VTS Series Firmware Version 1.8.0 Release Notes

November 28, 2005

These release notes describe new features added and bugs fixed since the firmware V1.7.0.1 release.

+ Added the virtual KVM support.

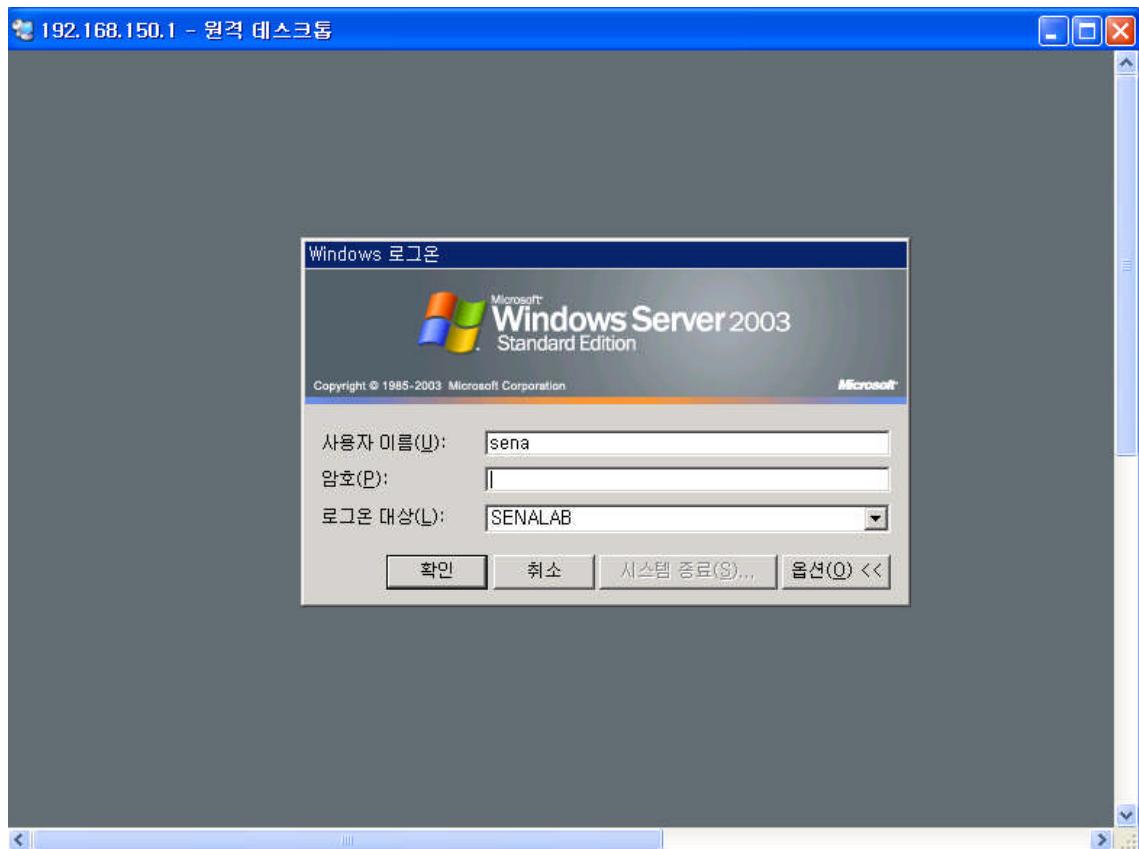
콘솔 서버 모드의 시리얼 포트에 연결된 호스트나 리모트 포트로 연결되는 원격 호스트가 KVM 기능을 제공할 경우, VTS는 사용자가 KVM 클라이언트 프로그램을 이용하여 호스트에 연결할 수 있는 수단을 제공합니다(Manual Page 64)

- Windows remote desktop connection, VNC, Radmin, Xmanager 및 User defined 지원합니다.

- Serial Port Connection 메뉴에 KVM에 접속할 수 있는 아이콘이 나타납니다.

+ Added an option to specify a system log file name.

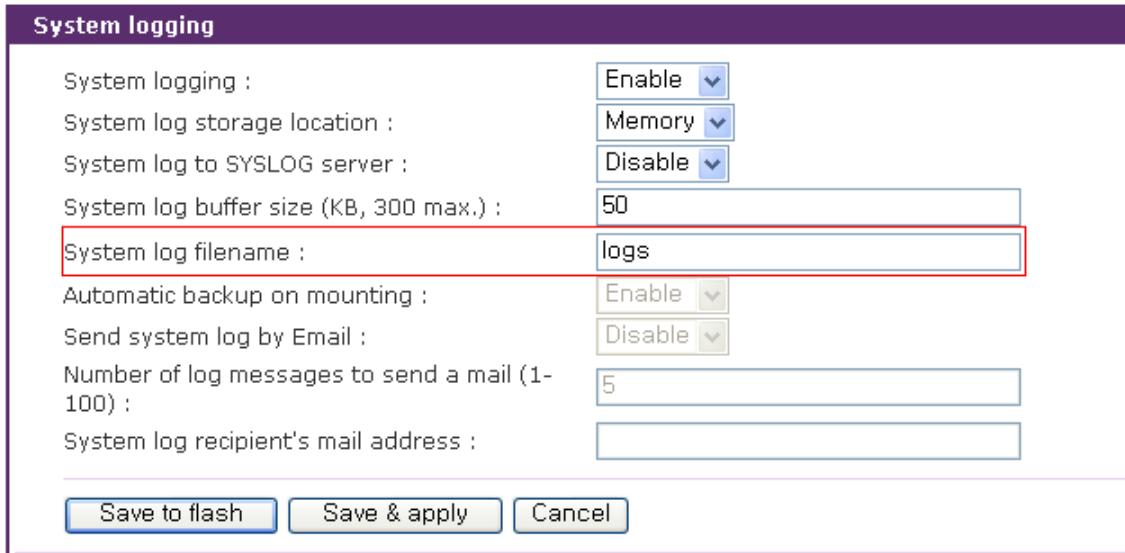
사용자가 System Log 의 저장 파일명을 지정할 수 있는 기능이 추가되었습니다. 기본값은 logs 입니다.(Manual page 120)
